# 6528 N BROAD ST

THIRD APPEARANCE 2024.05.07  
SECOND APPEARANCE 2024.03.05  
CIVIC DESIGN REVIEW 2023.10.10

# CDR APPLICATION

1 1-FIRST FLOOR  
 CDR 2 1" = 30'-0"

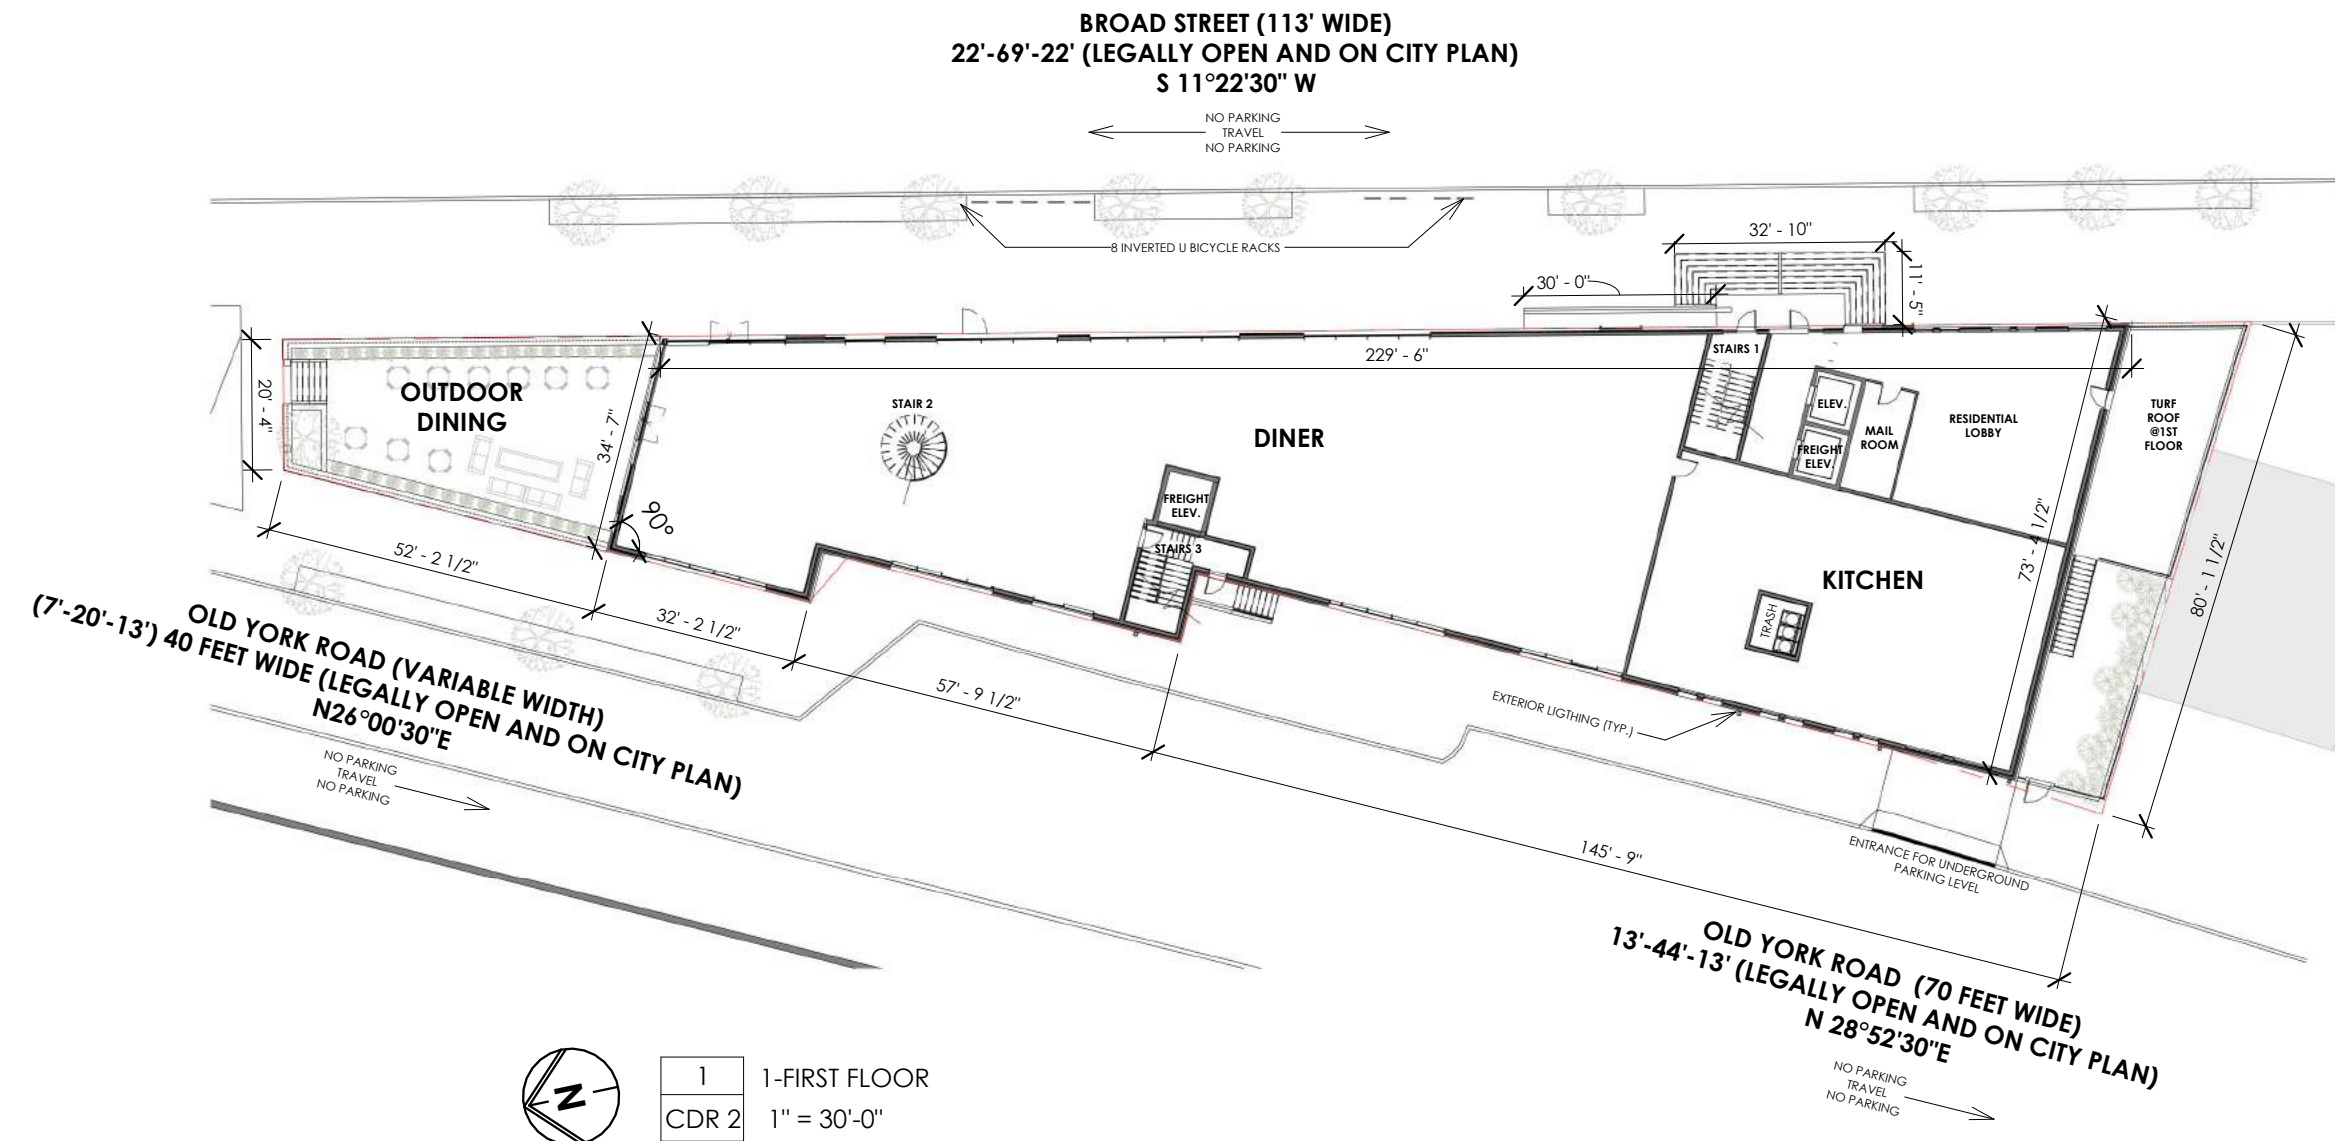
- .Questions about apparent leftover/awkwardly-shaped spaces labeled as Diner. Recommends that combination of first floor area around residential lobby and

We have reconfigured the first floor plan layout for a more cohesive and practical use.

We have added a direct pedestrian access from Old York Road into an outdoor seating area for the residents that have direct access from the residential lobby facing N Broad Street.

1 2-SECOND FLOOR  
CDR 3 1" = 30'-0"

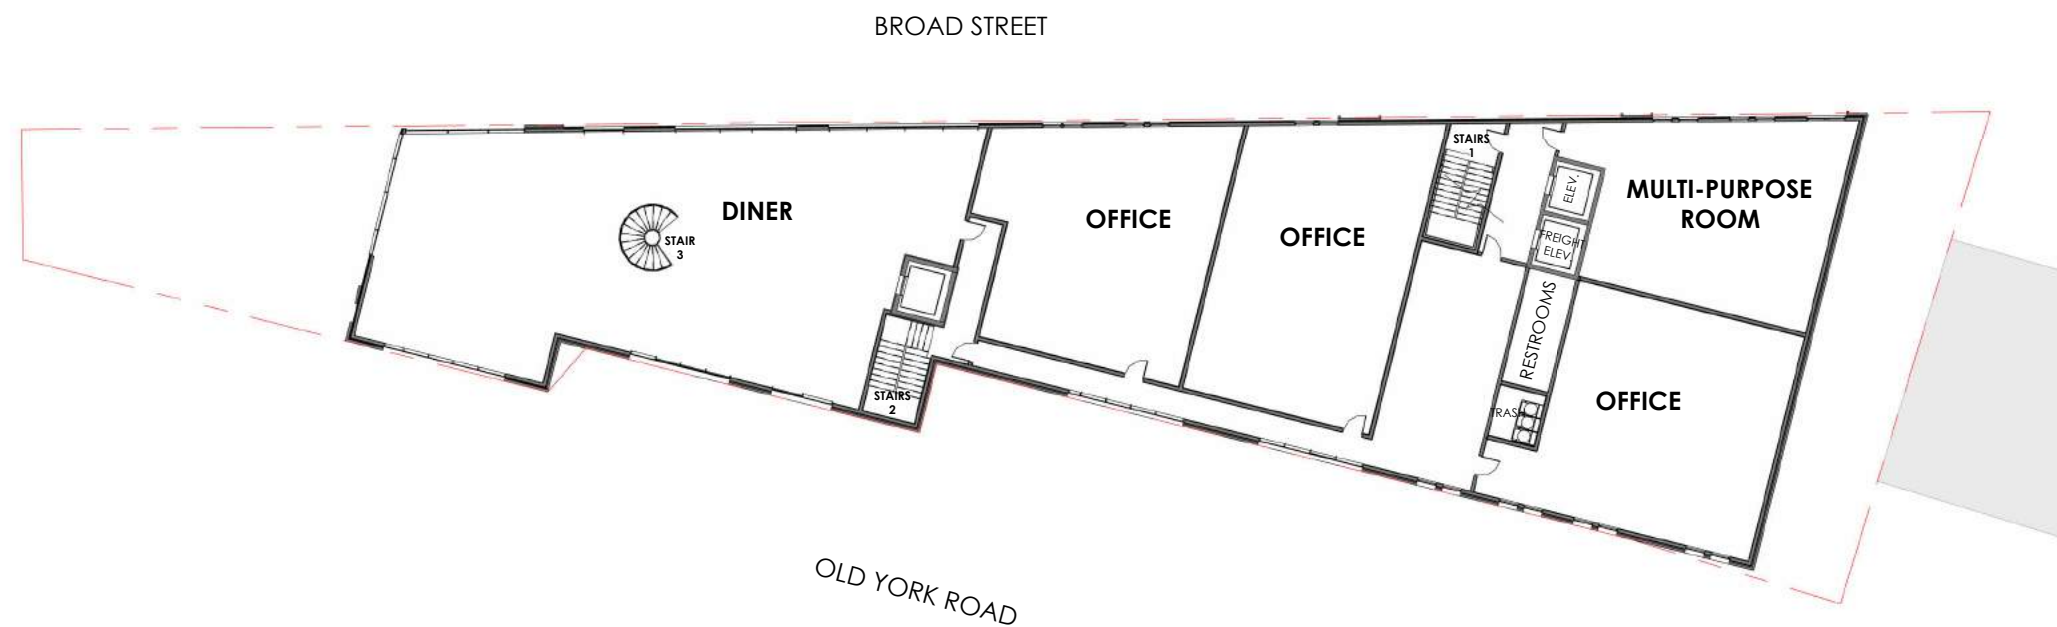
4. Requests for more detail on 2nd floor, including location of bathrooms and whether/how offices spaces may be available for use by residents.

We have delineated in more detail the proposed areas on the second floor plan.

1 SITE PLAN - LANDSCAPE PLAN  
 CDR 5 3/32" = 1'-0"

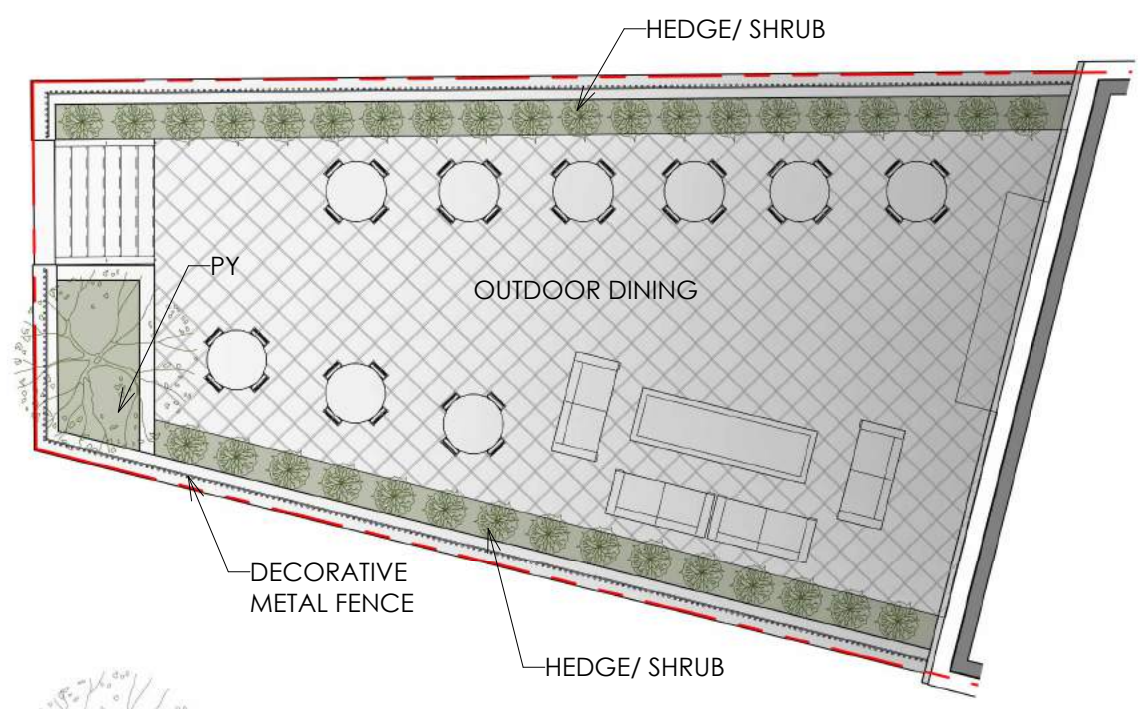
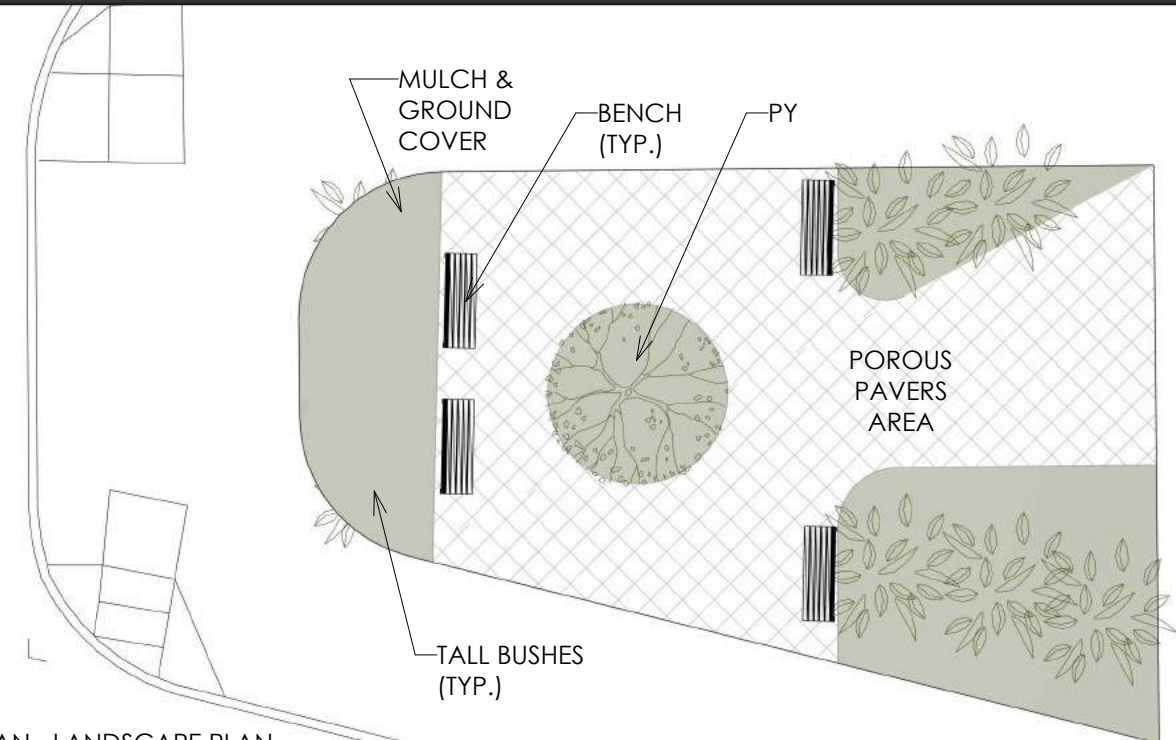
.Consider appropriateness of plant material.

.Ensure trees are planted in linear trenches to maximize growth potential.

We have revised the plant material.

We have revised the proposed street trees to be planted in linear trenches to maximize growth potential.
